City of San Antonio
TRANSPORTATION AND CAPITAL IMPROVEMENTS

ADDENDUM NO. 4

PROJECT NAME: **Ray Ellison (Loop 410 to Old Pearsall Road)**

PROJECT NO.: **40-00312**

SHEET 12 OF 16

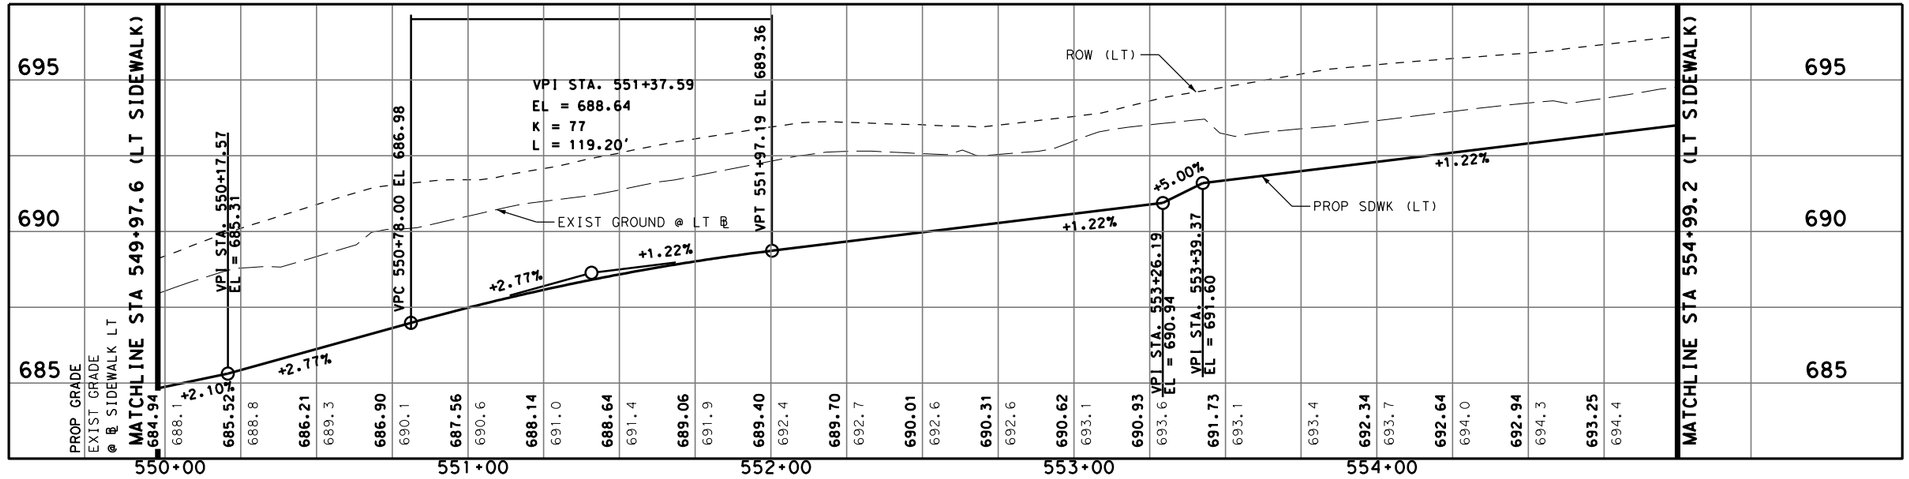
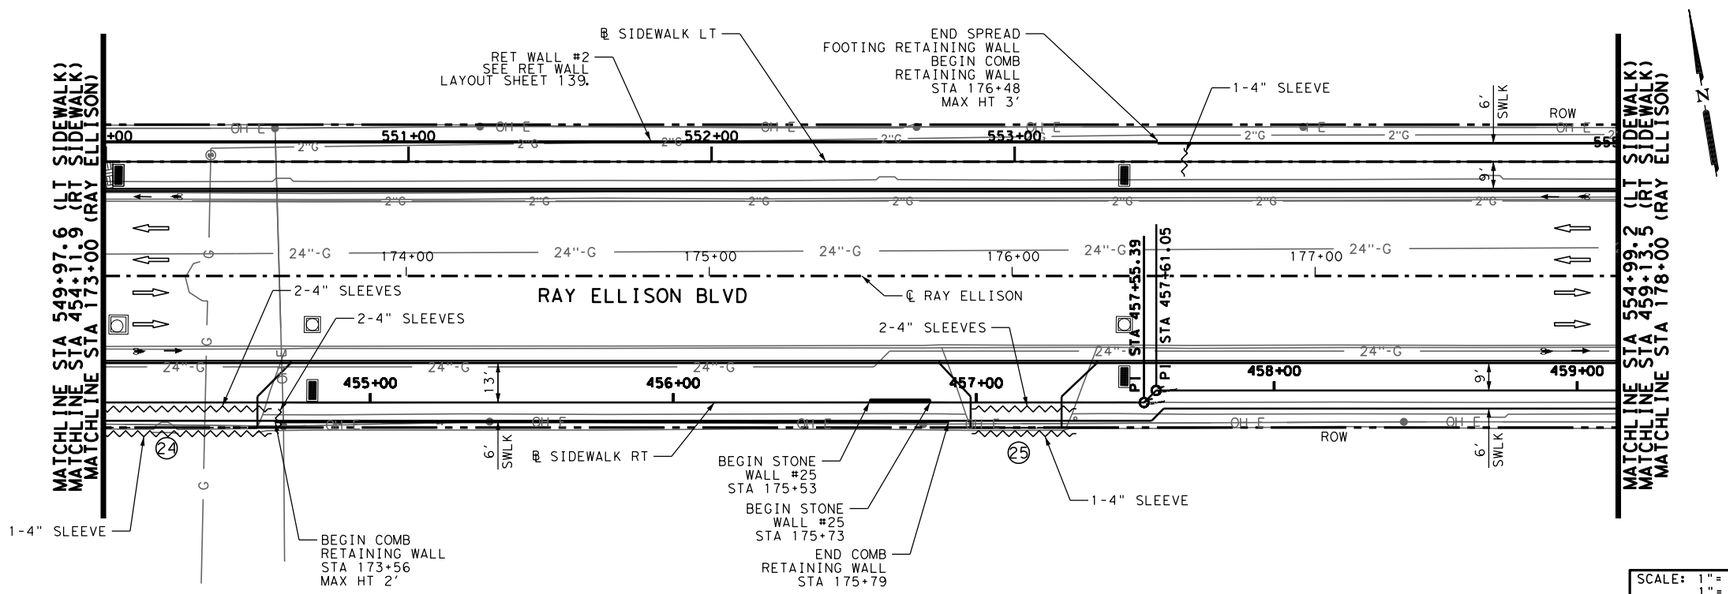
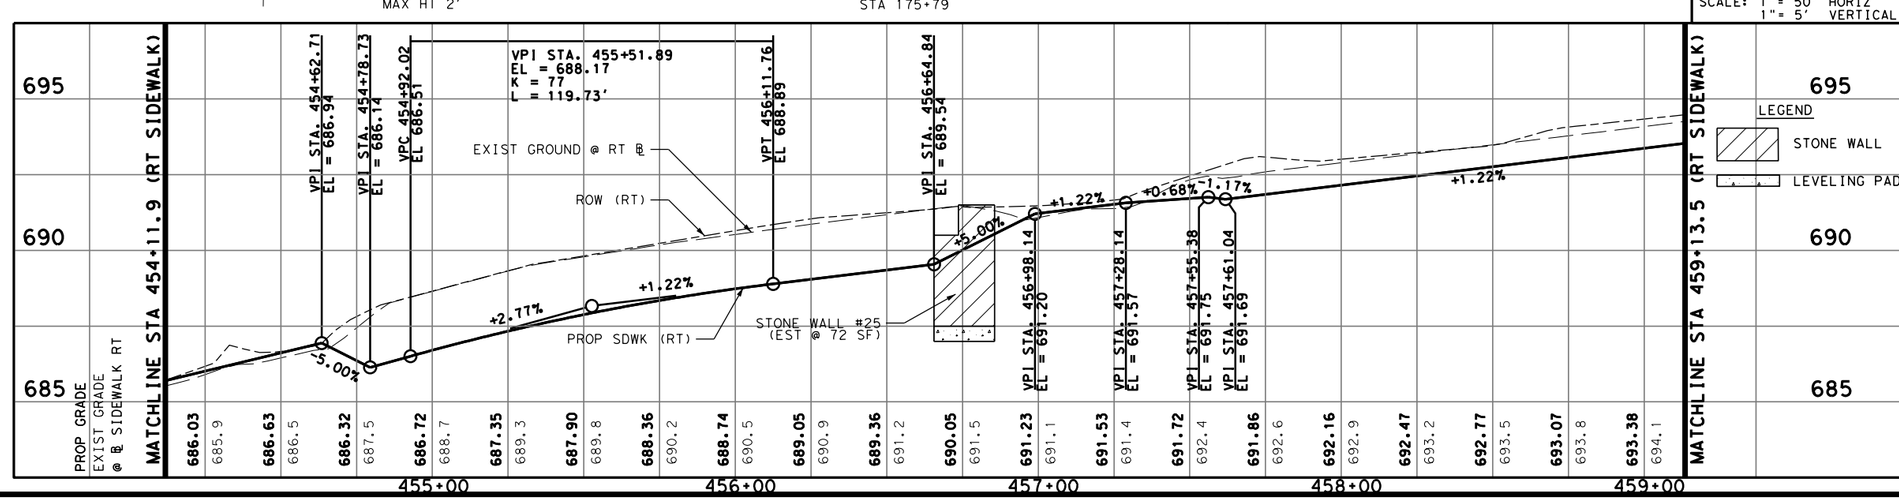
- Replace Sheet 122 “Sidewalk Plan & Profile Sheet STA 173+00 To STA 178+00” with Addendum No. 4 Sheet 122 “Sidewalk Plan & Profile Sheet STA 173+00 To STA 178+00” Revised retaining wall and sidewalk.

Response: No additional easements will be provided. Retaining wall and sidewalk are revised per Addendum 4.

TYPICAL RETAINING WALL SECTION

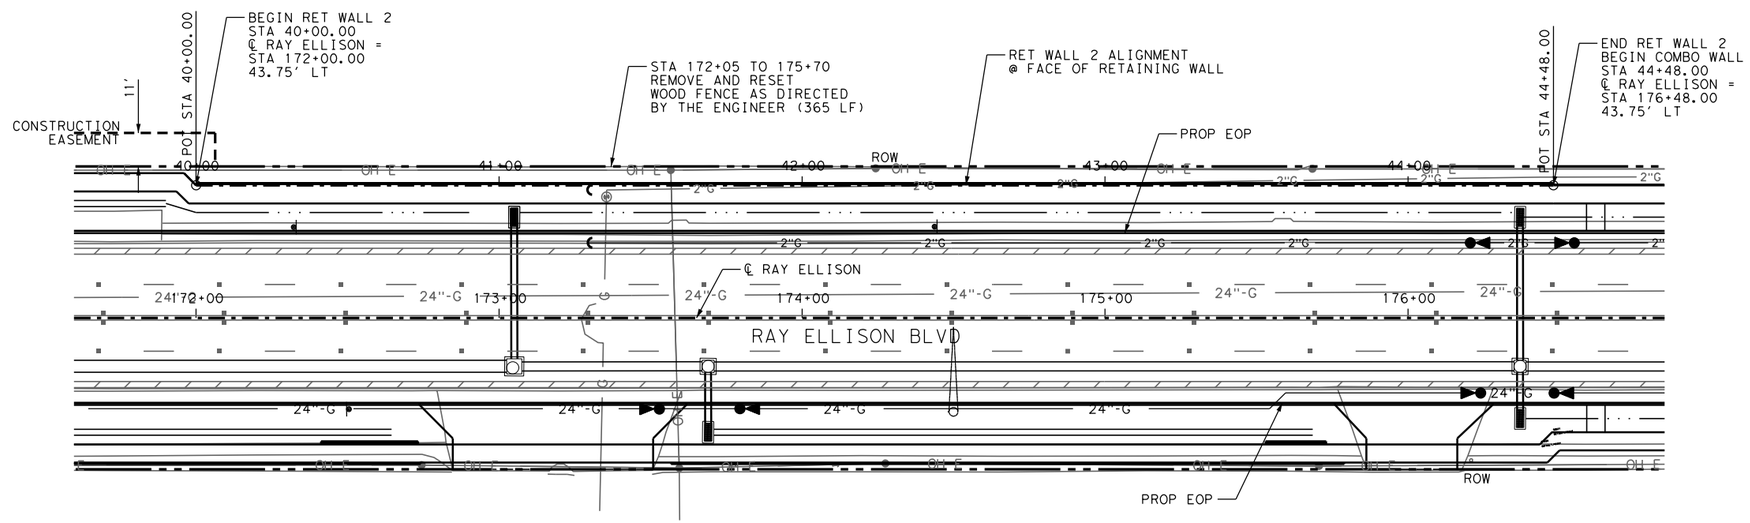
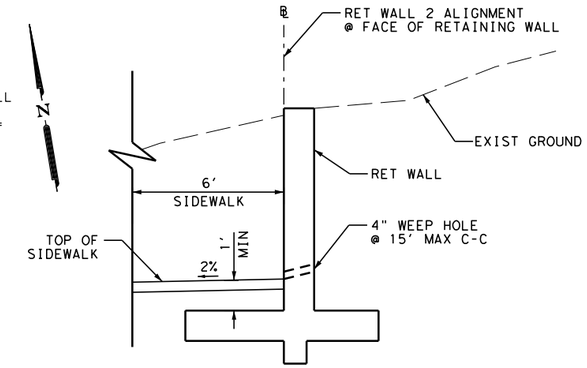
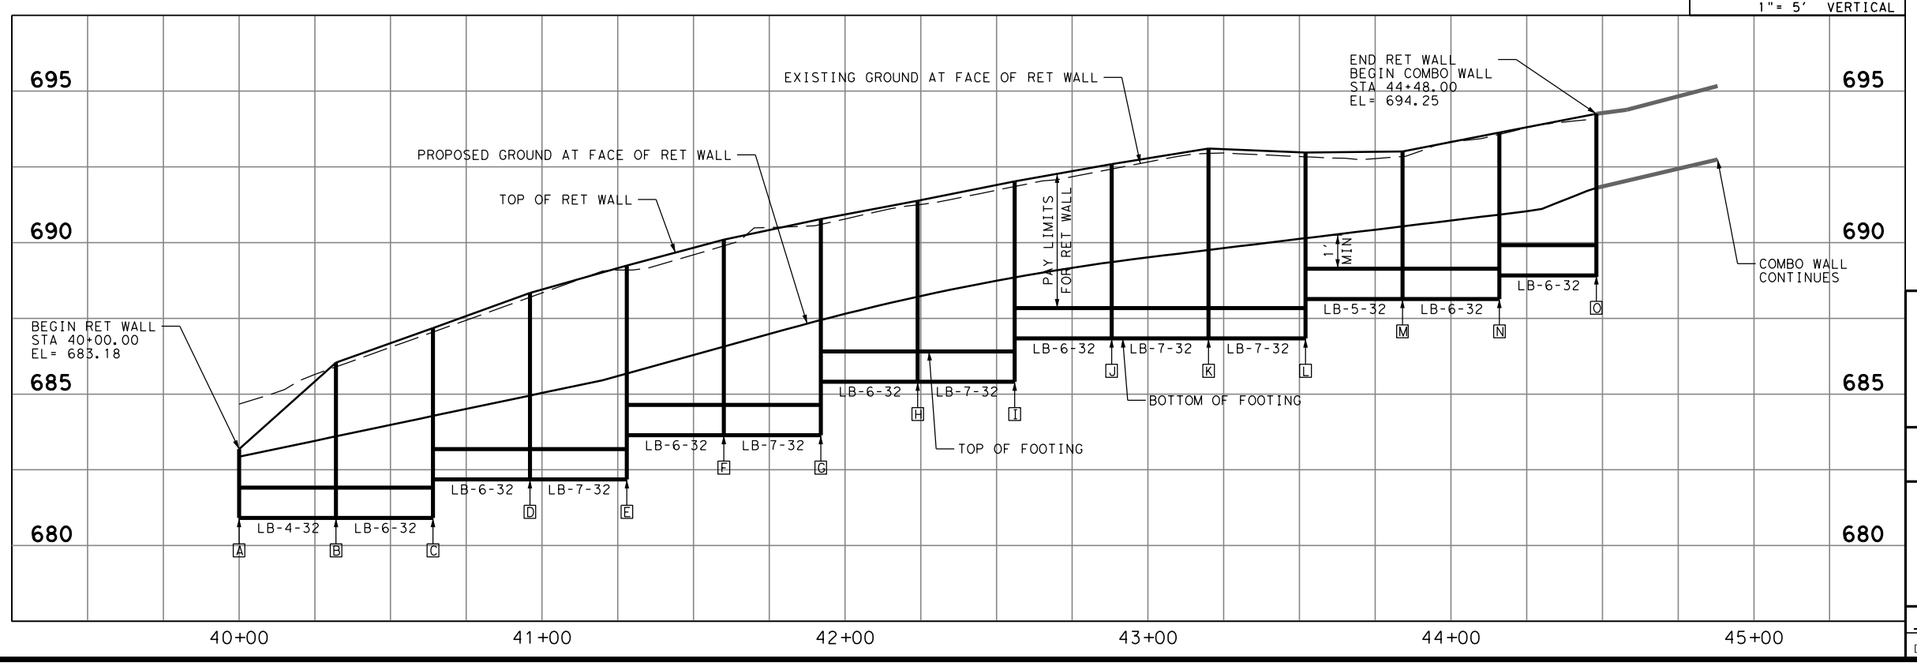
- Replace Sheet 139 “Retaining Wall 2 Layout” with Addendum No. 4 Sheet 139 “Retaining Wall 2 Layout” Revised retaining wall and sidewalk.
- Replace Sheet 169 “Drainage Computations System C” with Addendum No. 4 Sheet 169 “Drainage Computations System C” Revised hydraulics.

SHEET 15 OF 20

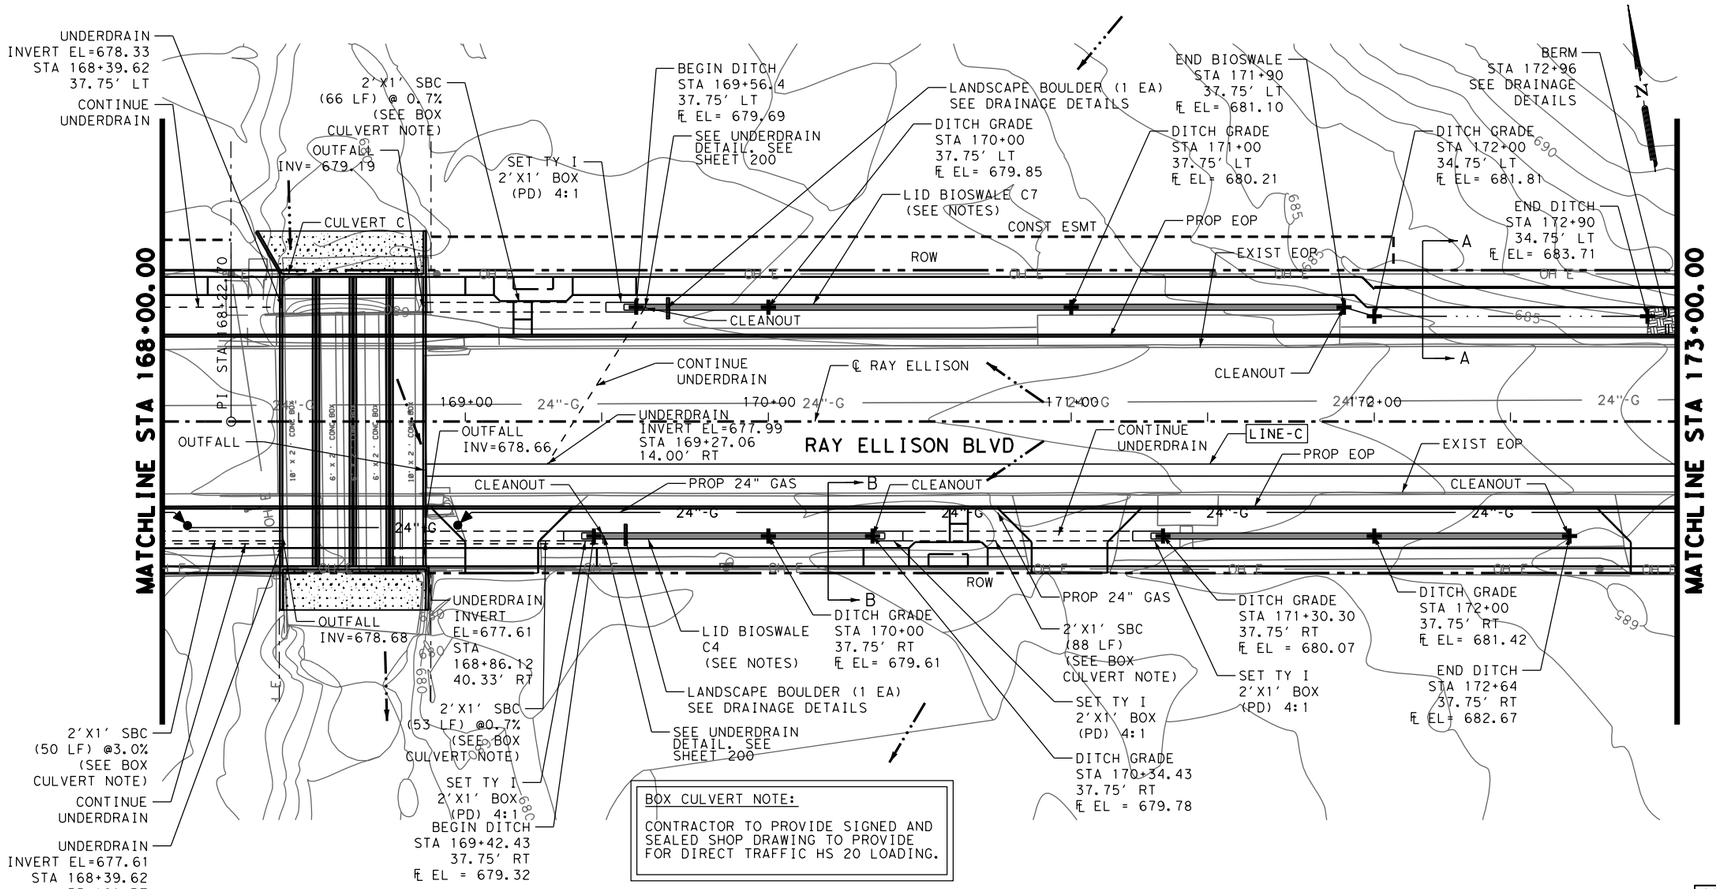
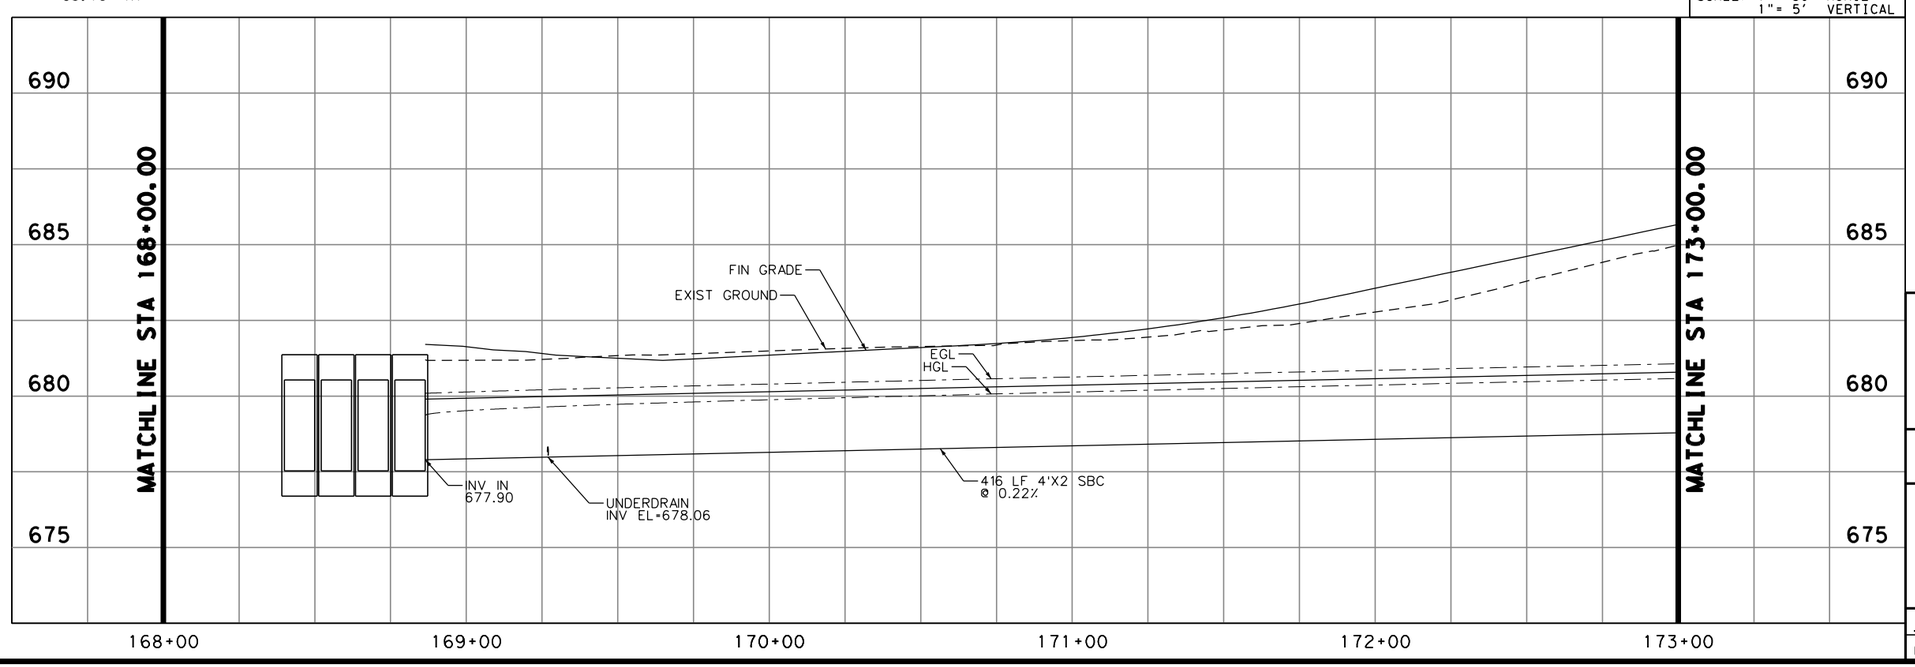
- Replace Sheet 171 “Ditch Hydraulic Data Sheet” with Addendum No. 4 Sheet 171 “Ditch Hydraulic Data Sheet” Revised ditch.
- Replace Sheet 187 “Storm Drain Plan & Profile System C” with Addendum No. 4 Sheet 187 “Storm Drain Plan & Profile System C” Revised ditch.

SHEET 16 OF 20

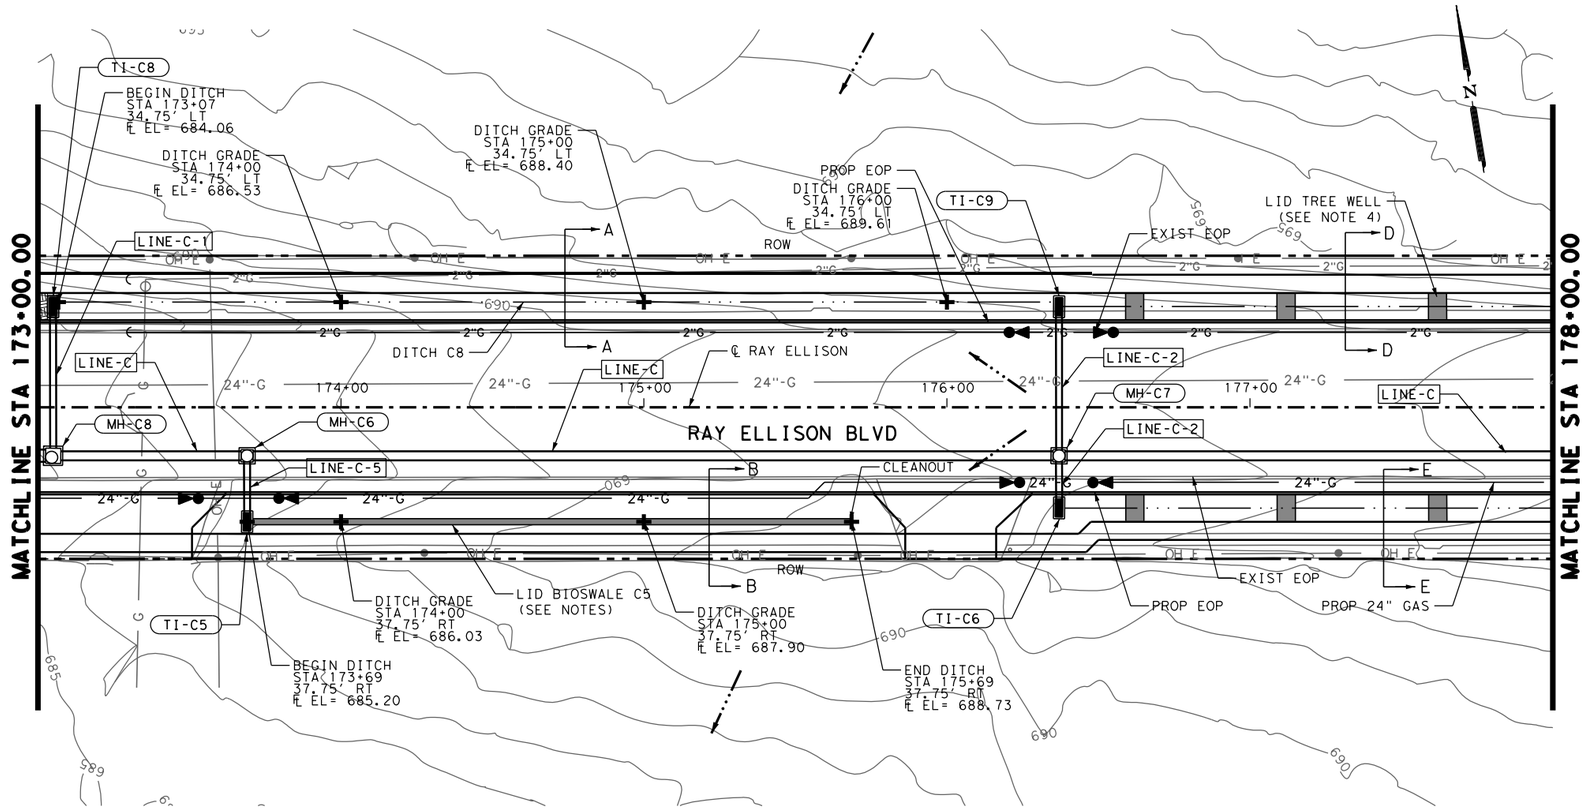
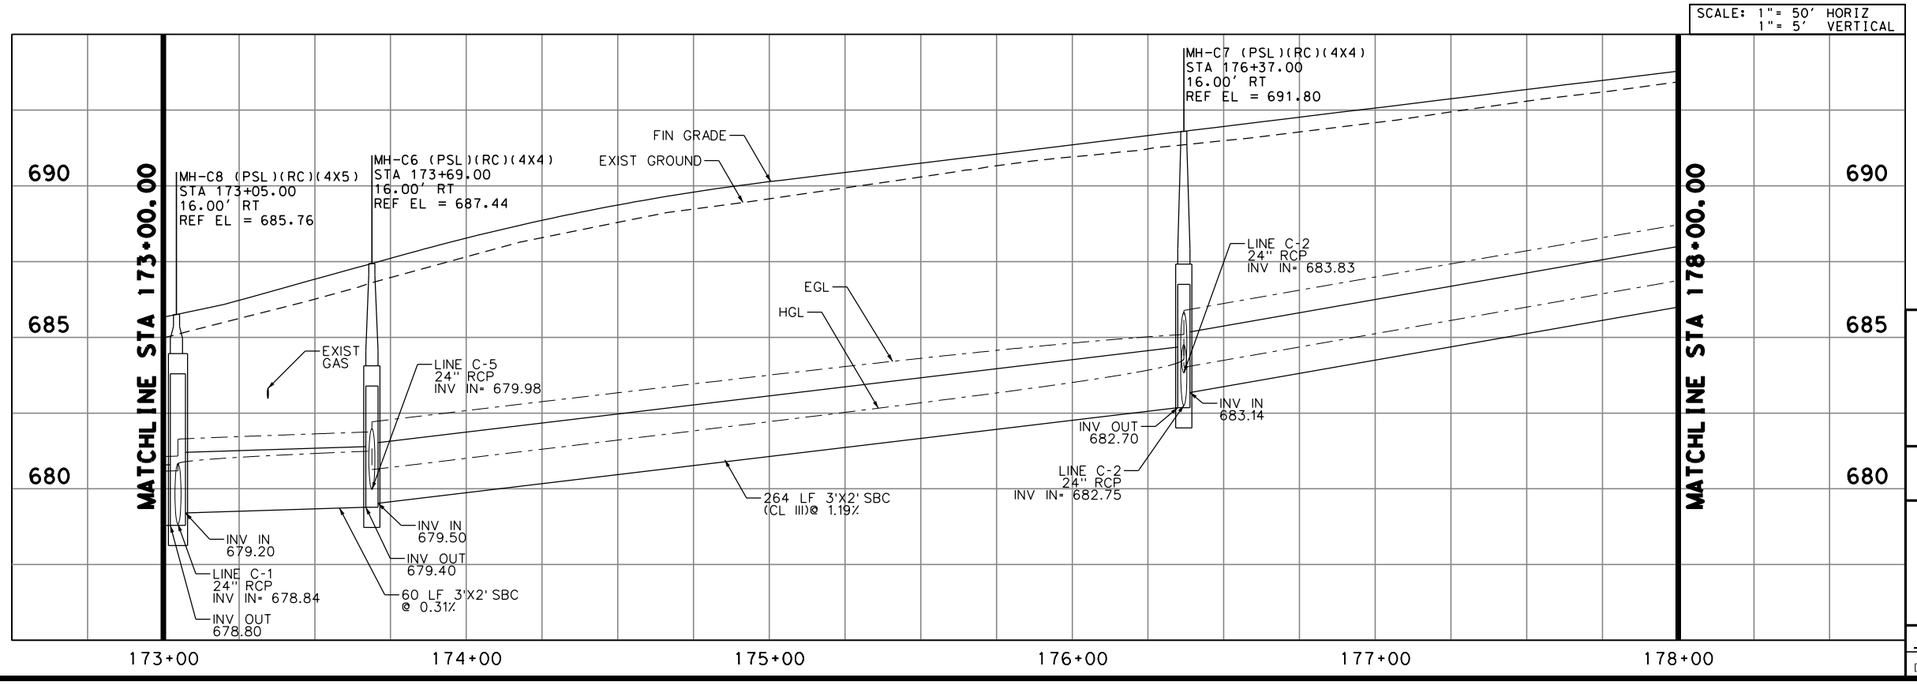
- Replace Sheet 188 “Storm Drain Plan & Profile System C” with Addendum No. 4 Sheet 188 “Storm Drain Plan & Profile System C” Revised ditch.
- Replace Sheet 198 “Storm Drain Laterals” with Addendum No. 4 Sheet 198 “Storm Drain Laterals” Revised line C-1.
